Report to Sydney Central City Planning Panel

SWCCP reference	2017SWC101
DA No.	729/2017
Date of receipt	23 August 2017
Proposal	Residential flat building
Street address	2-6 Paul Place, Carlingford NSW 2118 4 Tanderra Avenue, Carlingford NSW 2118
Property Description	Lot 21, Lot 22, Lot 23 and Lot 24 in DP 216984
Applicant	A1 Green Garden Pty Ltd
Owner	Qun Lin – A1 Green Garden Pty Ltd. XiaoShi Dai Yu Chen Jim Arvanitis Xiao Qing Wang
Submissions	One
List of All Relevant s79C(1)(a) Matters	<ul style="list-style-type: none">• Environmental Planning and Assessment Act and Regulations• State Environmental Planning Policy No. 55• State Environmental Planning Policy (Vegetation in non-rural areas) 2017• State Environmental Planning Policy (Affordable Rental Housing) 2009• State Environmental Planning Policy No. 65 (Design Quality of Residential Apartment Development)• State Environmental Planning Policy (Sydney Harbour Catchment) 2005• State Environmental Planning Policy (Building Sustainability Index: BASIX)• State Environmental Planning Policy (State and Regional Development) 2011• The Hills Local Environmental Plan 2012

Recommendation	Refusal

Figure 4: Identification of Trees to be removed using data from Arborist Report. Red trees to be removed. Blue trees to be retained.

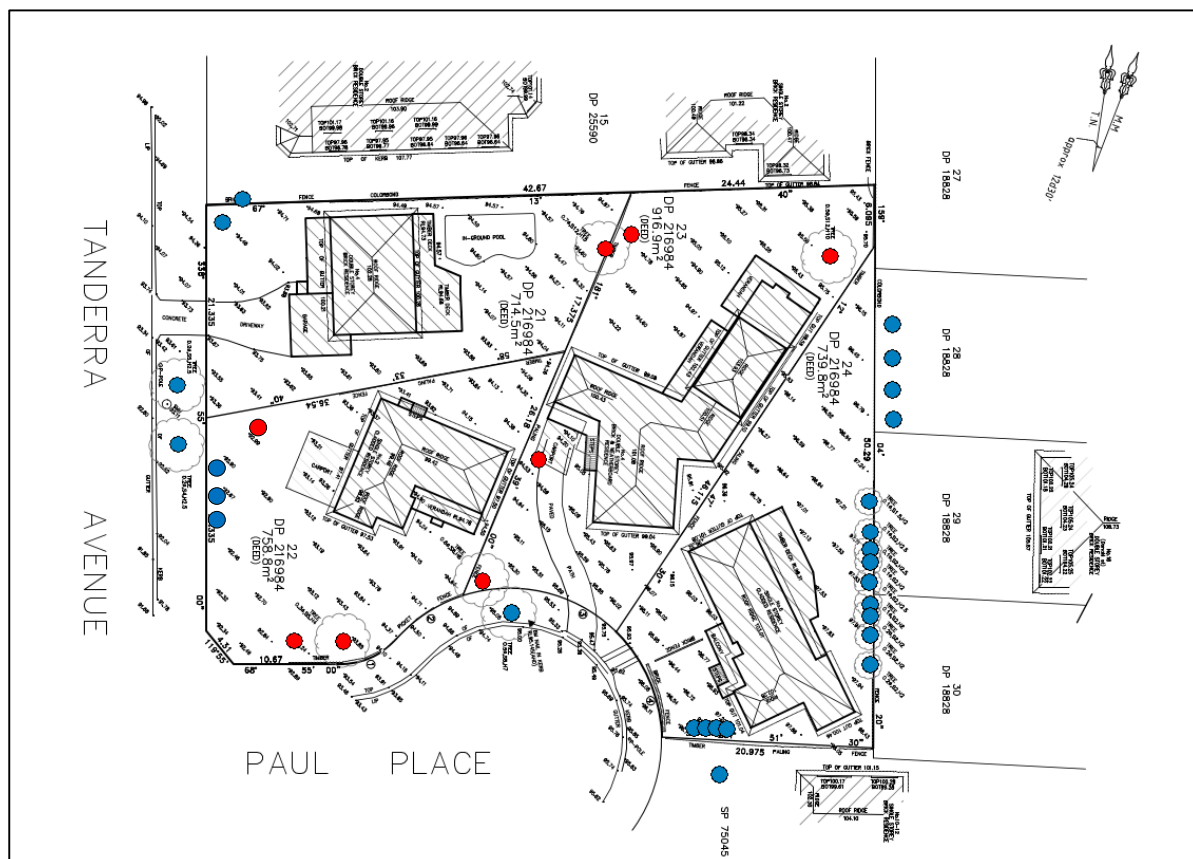
- Tree 8, 9, and 19 failed a visual tree assessment and are not considered suitable for retention.
- Tree 10, 11, 12, 14, and 15 are suitable to be considered for retention but are impacted by the proposed plans.

Subject to conditions for replanting and the protection of the remaining trees on site, and replanting of street trees, the application meets the aims of the SEPP.

Figure 11: Extract of Level 4 floor plan showing inaccessible planter boxes indicated in red.

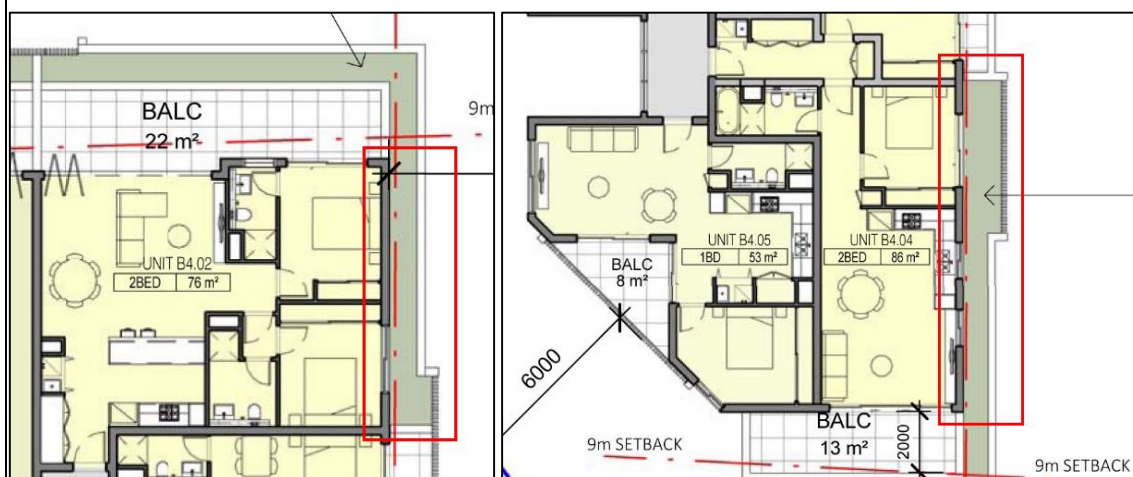
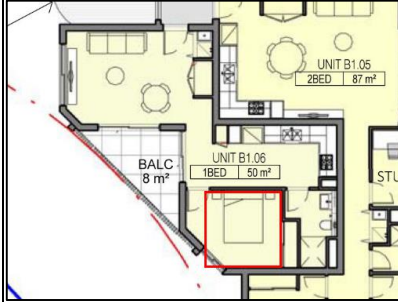
It is noted that the planter boxes used are not appropriately located to allow for maintenance. In particular, the planter boxes located in the north-eastern and south western corner of the development are located in spaces with no access with the exception of windows to bedrooms or the kitchen. See Figure 11 below:

Notwithstanding the use of planter boxes as a means of providing additional separation, the edge of the accessible balcony should be setback 9 metres from the northern, eastern and southern boundaries to provide equitable separation distances without burdening adjoining developments.

Figure 14: Extract of Height Plane showing areas of non-compliance

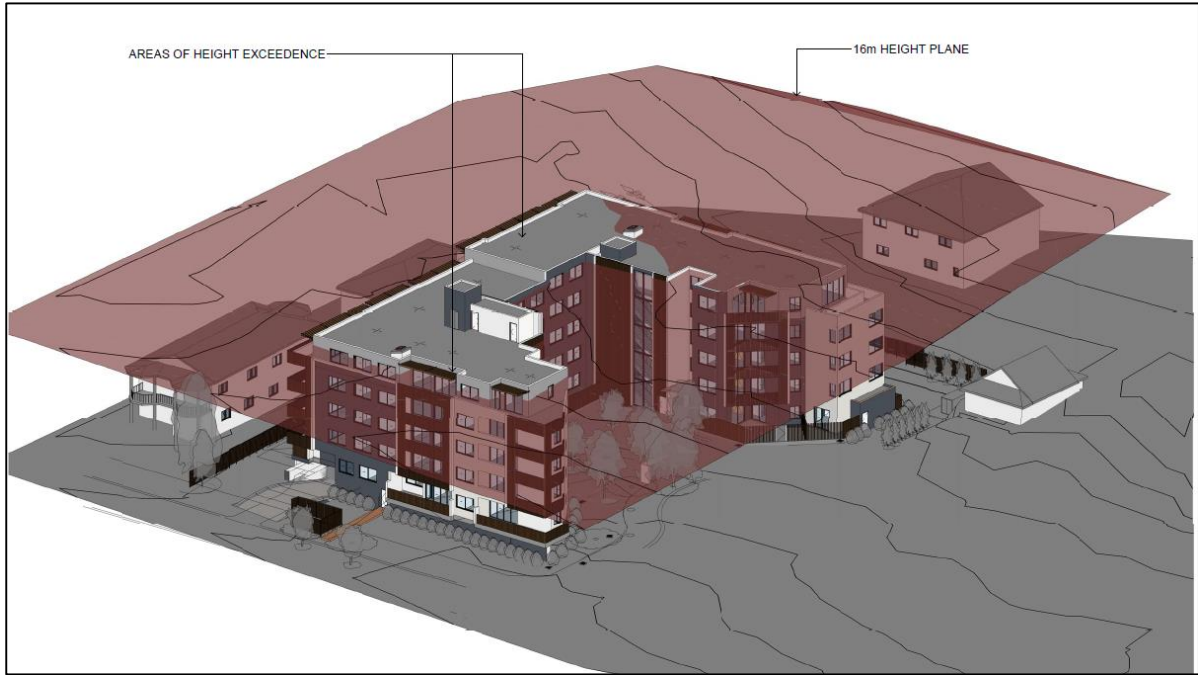
Clause 4.3(2) of The Hills LEP 2012 identifies a site on which a building is to be erected shall not exceed 16 metres in height. The application proposes a maximum building height of 21.3 metres, which is a variation of 5.3 metres or 33.1%. See Figure 14, 15, 16, and 17 below:

- The flood planning level is a site constraint that must be accommodated within the design of the development.
- Despite the flood planning level of the site, the Height Plane (Figure 8 above) illustrates that the exceedance is not only the rooftop communal open space and lift overrun, however also includes a significant portion of the roof, ceiling, and external walls of the top floor.
